City of Sugar Hill Planning Staff Report **DRB TCO 17-00287**

DATE:April 25, 2018TO:Mayor and Council, Design Review BoardFROM:Planning DirectorSUBJECT:Town Center Overlay District (TCO) Design Review
Tax Parcel: 7-292-142 First Avenue

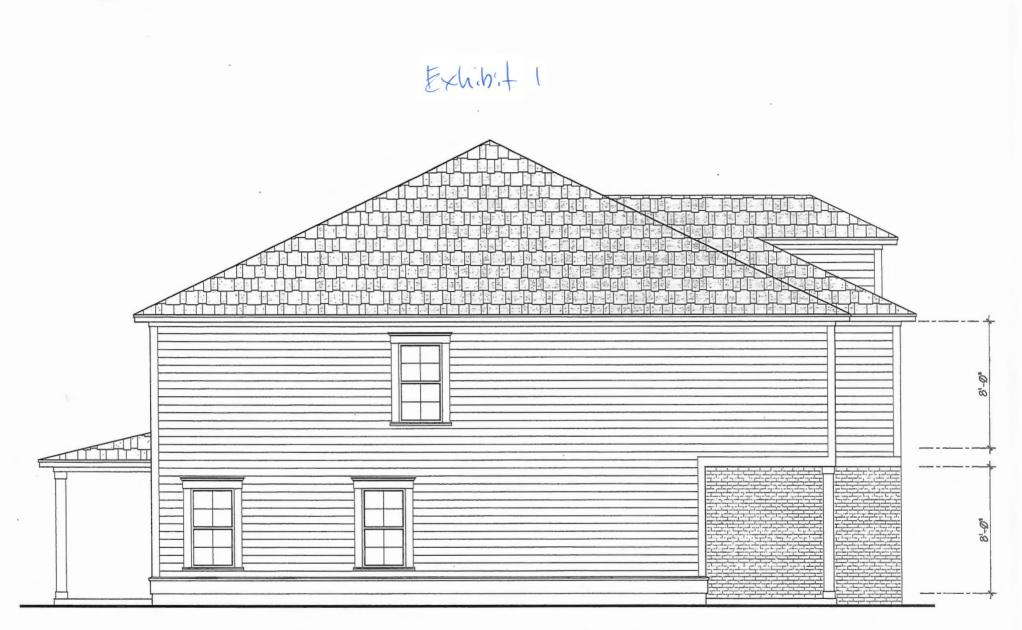
There are two newer duplexes nearby on First Avenue. This duplex, developed appropriately should be consistent with the area and continue the trend of redevelopment on First Avenue in a positive way.
